Access Compliance Report

Public Rights-of-Way

Intersection ID: 29429	Main Street: BRADSTREET_COMMONS_WY	Cross Street: DELUCA_DR	Location: NE
ADA ID: D98FDEA18195	Ramp Type: BlendTrans1	Initial Pass/Fail: Pass	Overall Compliance: No
Severity Score: 5.25			
Codes/Mitigation Info/Possible Solution		Field Measurements/Component Compliance

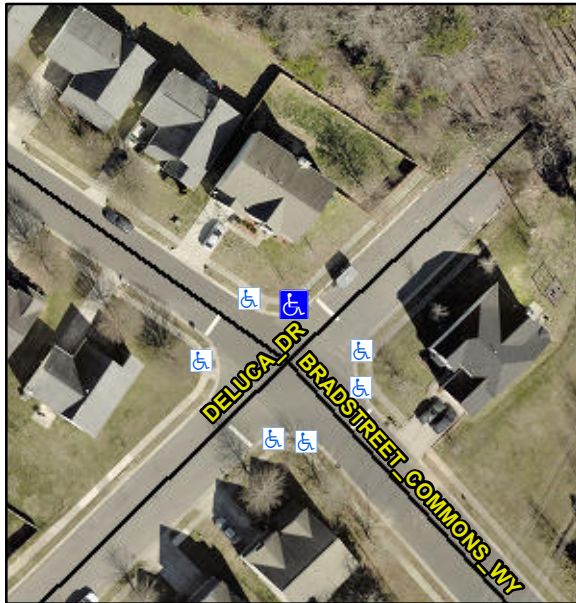
Not Found, R304.5.3, R304.2.1, R304.2.2-Perp, R304.3.2-Para, R305.2, R302.7, R304.5.4

Compliance	Description	Data	Compliance	Description	Data
N/A	Ramp Length (in)	47.0	Yes	BlendTrans Slope (%)	3.1
Yes	Ramp Width (in)	48.0	No	BlendTrans XSlope (%)	3.2
N/A	Flare Type LT	Sloped	N/A	Flare Type RT	Sloped
N/A	Flare Slope LT (%)	1.6	N/A	Flare Slope RT (%)	5.3
N/A	Flare Traversable LT?	No	N/A	Flare Traversable RT?	No
Yes	Landing Length (in)	48.0	Yes	DWS Provided?	Yes
No	Landing Width (in)	46.5	Yes	DWS Contrast?	Yes
No	Landing Slope (%)	4.3	Yes	DWS Length (in)	24.5
Yes	Landing X Slope (%)	1.3	Yes	DWS Full Width?	Yes
N/A	Landing Curb? (Y/N)	No	No	DWS Offset (in)	7.5
N/A	Shared Landing?	No			
No	Gutter Ponding?	Yes	No	Gutter Slope (%)	5.8
Yes	Gutter Lip Ht (in)	0.0	No	Gutter X Slope (%)	3.8
N/A	Painted X Walk1?	No	N/A	Painted X Walk2?	N/A
	X Walk 1 Direction	To SE		X Walk 2 Direction	N/A
	X Walk 1 Width (in)	N/A		X Walk 2 Width (in)	N/A
	X Walk 1 Slope (%)	1.7		X Walk 2 Slope (%)	N/A
	X Walk 1 X Slope (%)	2.6		X Walk 2 X Slope (%)	N/A

N/A	Ramp inside XWalk1?	N/A	N/A	Ramp inside XWalk2?	N/A
	Road Slope (%)	2.6		Clear Space?	Yes
	Road X Slope (%)	1.7	N/A	Clear Space to XWalk (in)	N/A
Yes	Any Obstructions?	No	Yes	Storm Grate/Utility Hazard?	No
	Obstruction Type			Storm Grate/Utility Type	
		N/A			N/A
			Yes	Surface Condition? (G/P)	Good
			No	Curb Slope (%)	34.7

Remove & Replace Curb Ramp With Two New Directional Ramps or Equivalent. Remove & Replace Gutter.
